**Champlain Hudson Power Express ("CHPE")
Environmental Management & Construction Plan
Notice of Major Change**

Project: Champlain Hudson Power Express

Segment: 10

Notice Number: 084

PERMIT DRAWING NO.
 DRAWING NO.
C-102
 19

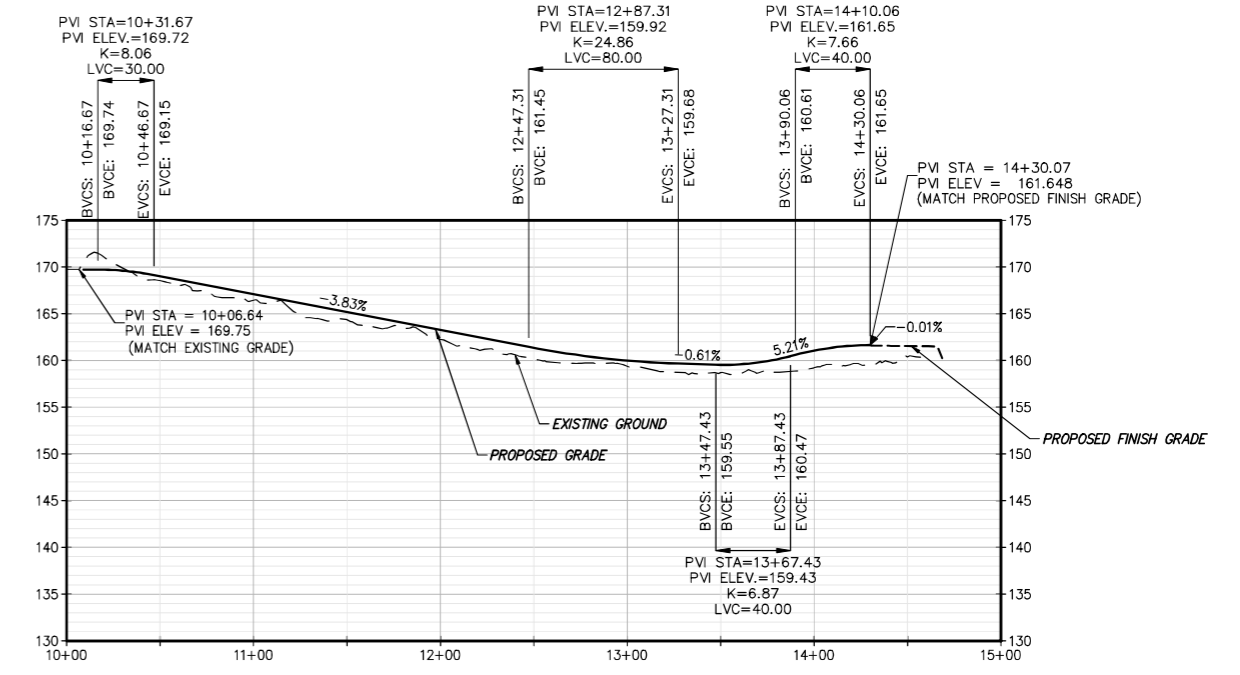
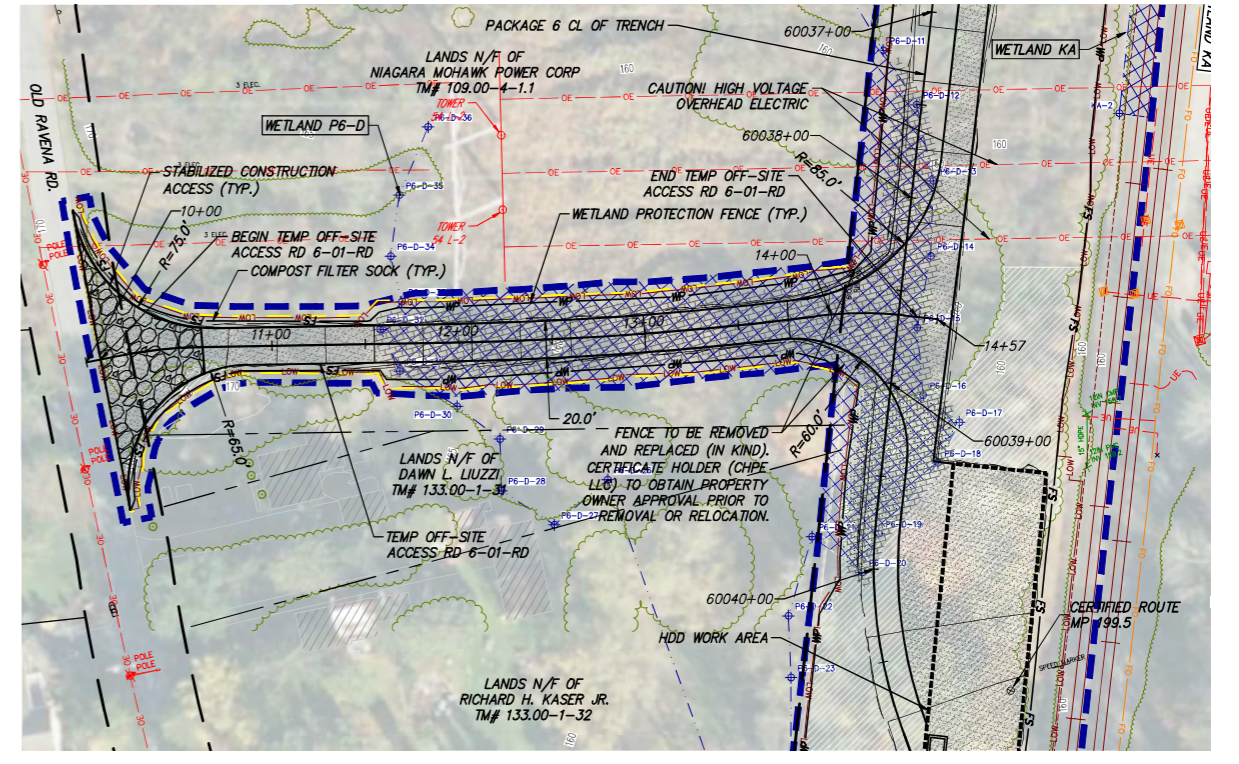
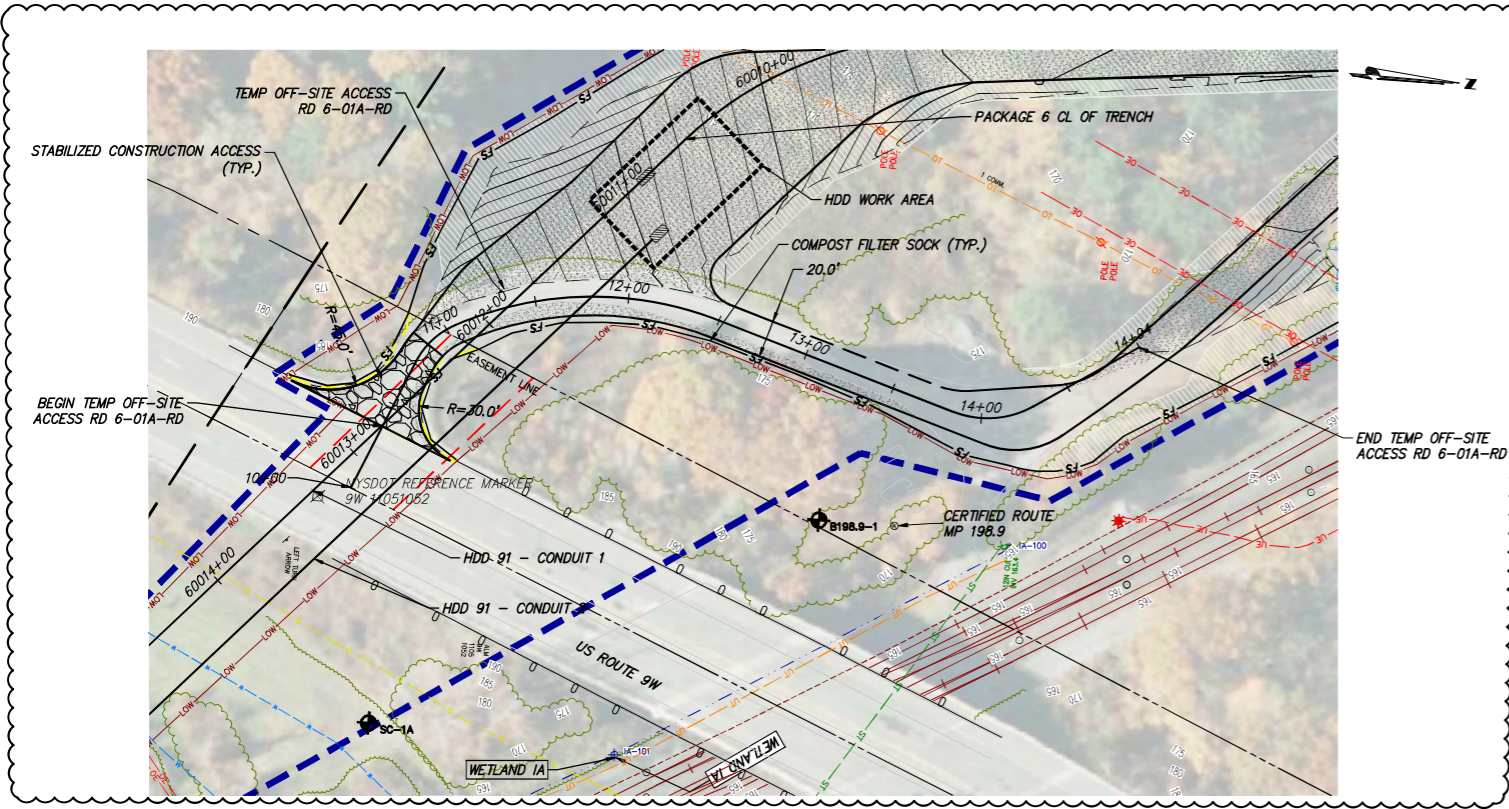
No.	DATE	SUBMITTAL / REVISION DESCRIPTION	DB	APP
1	02/13/2024	NDC-0054_HDD 91 REALIGNMENT FOR NEW RTE 9W BRIDGE	BL	RJ
0	08/29/2023	ISSUED FOR CONSTRUCTION SUBMISSION	BV	TK

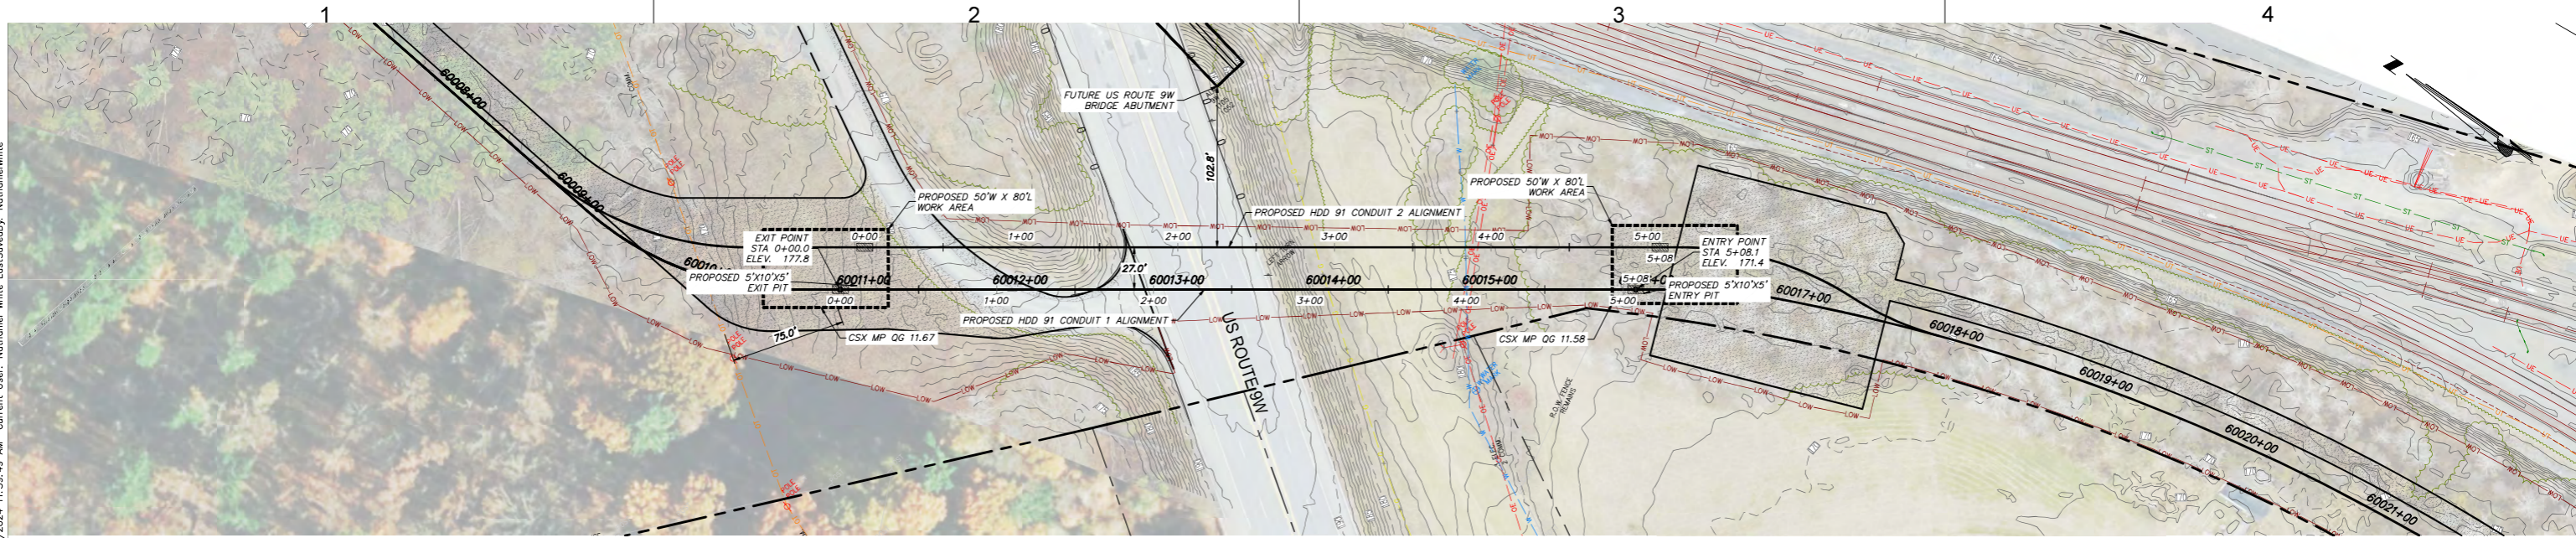
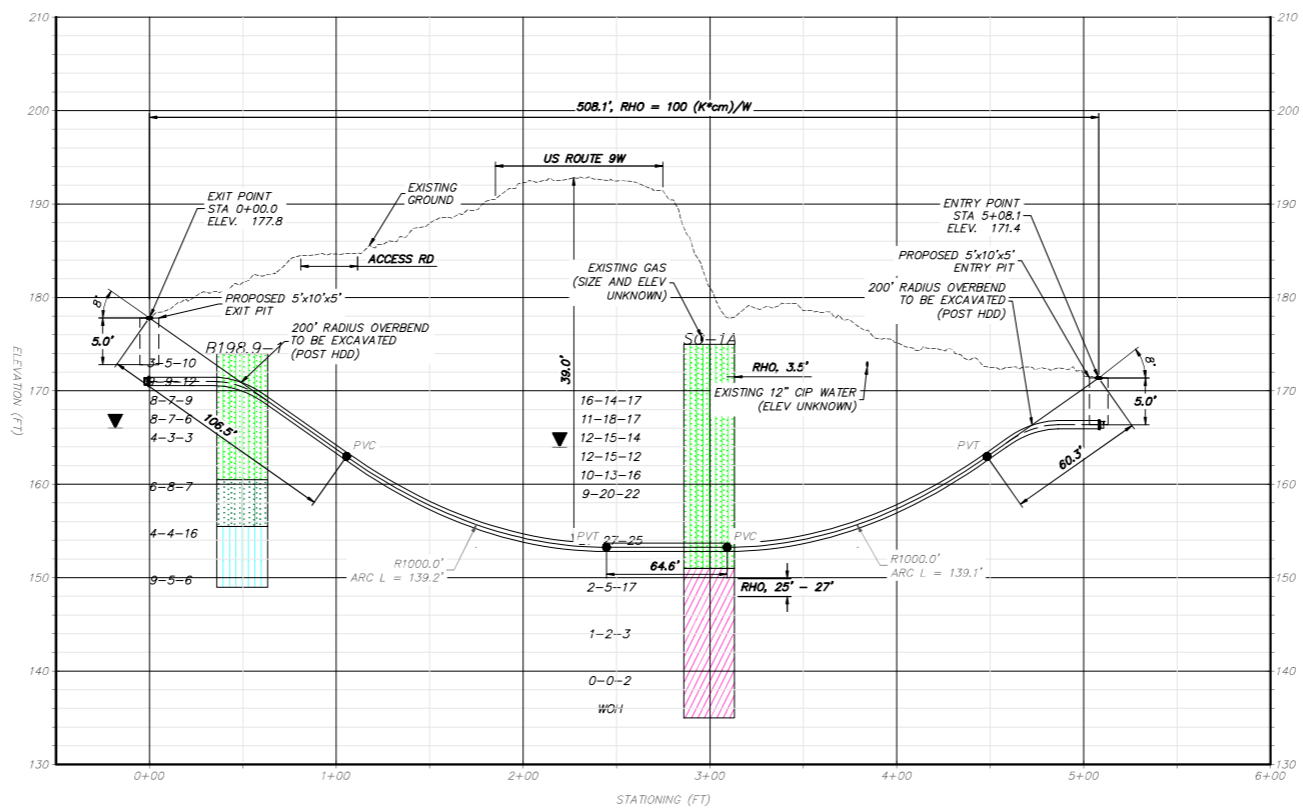
No.	DATE	SUBMITTAL / REVISION DESCRIPTION	DB				APP																
1	02/13/2024	NDC-0054_HDD 91 REALIGNMENT FOR NEW RTE 9W BRIDGE	SA	TK																			
0	11/29/2023	ISSUED FOR CONSTRUCTION SUBMISSION	BV	TK																			
				<table border="1"> <thead> <tr> <th colspan="2">DRAWN BY:</th> <th colspan="2">DESIGNED BY:</th> <th colspan="2">APPROVED BY:</th> <th colspan="2">SCALE</th> </tr> </thead> <tbody> <tr> <td>NW</td> <td>SA</td> <td>TK</td> <td>AS SHOWN</td> <td>DATE:</td> <td>11/29/2023</td> <td></td> <td></td> </tr> </tbody> </table>	DRAWN BY:		DESIGNED BY:		APPROVED BY:		SCALE		NW	SA	TK	AS SHOWN	DATE:	11/29/2023			DRAWING NO.		
DRAWN BY:		DESIGNED BY:		APPROVED BY:		SCALE																	
NW	SA	TK	AS SHOWN	DATE:	11/29/2023																		
								<p>C-301</p>

PERMIT DRAWING NO.	N/A
DRAWING NO.	C-401

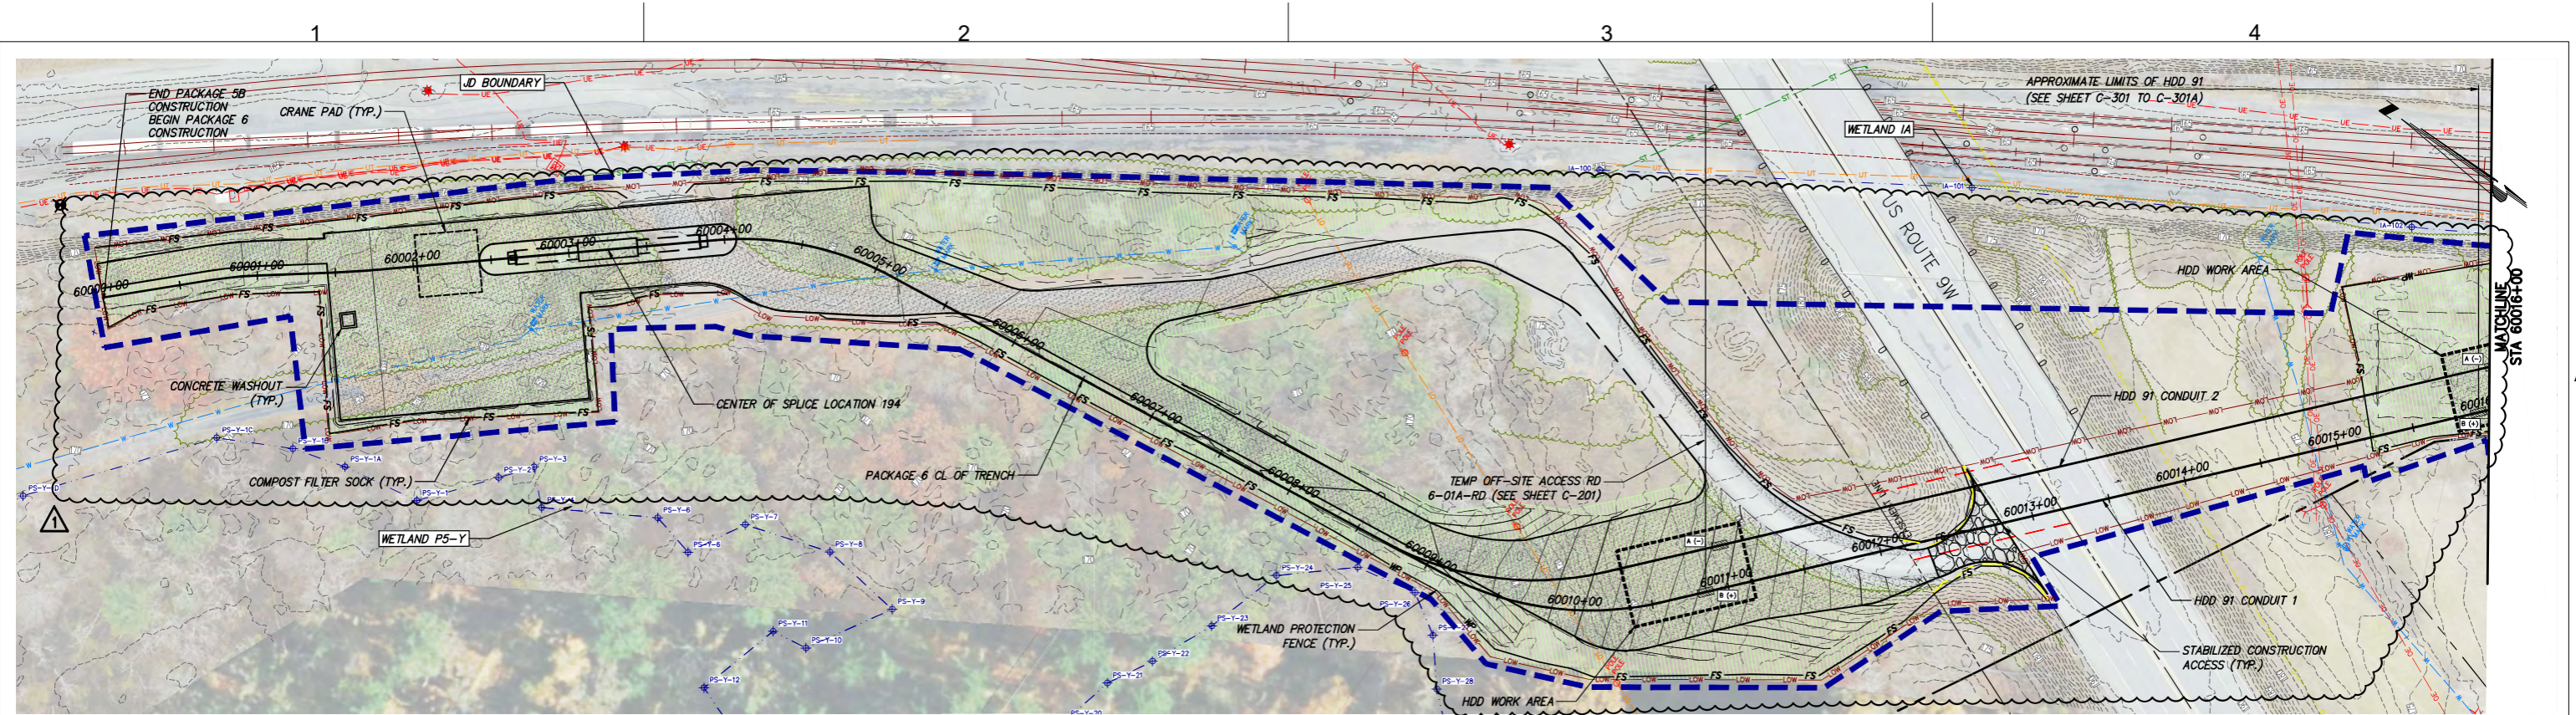
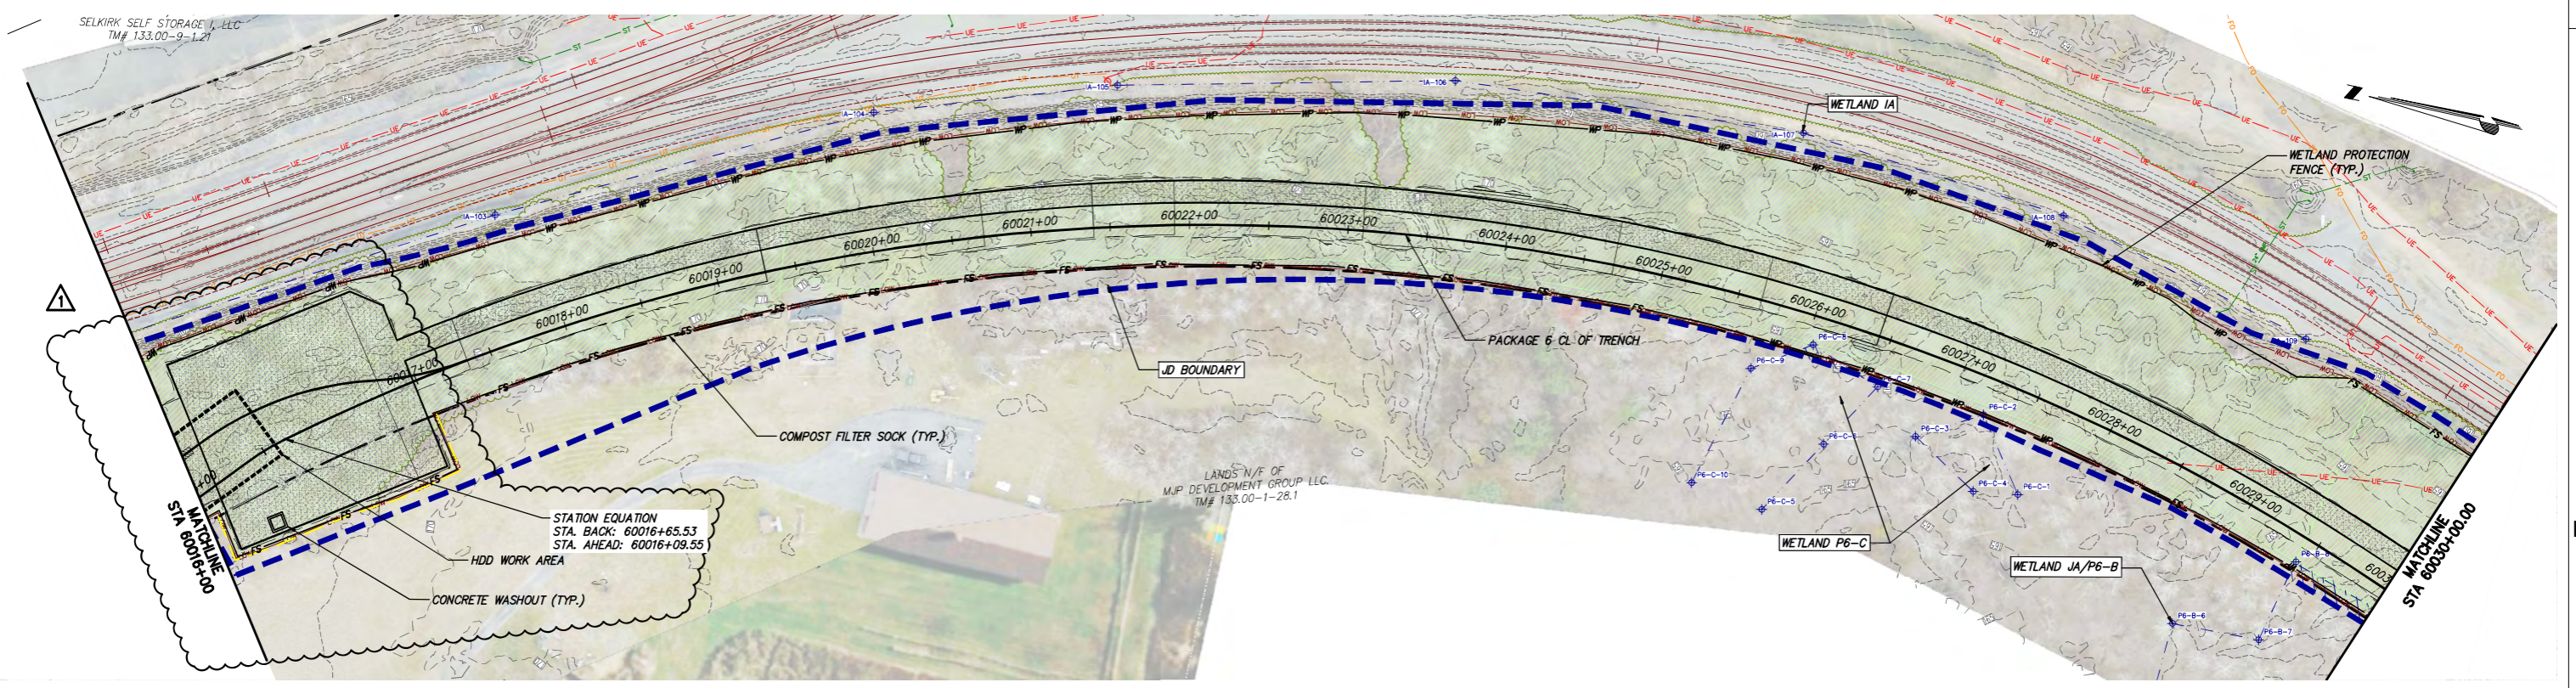
No.	DATE	SUBMITTAL / REVISION DESCRIPTION	DB	APP
1	02/13/2024	NDC-0054: HDD 91 REALIGNMENT FOR NEW RTE 9W BRIDGE	JR	BD
0	09/29/2023	ISSUED FOR CONSTRUCTION SUBMISSION	TH/MK	NH
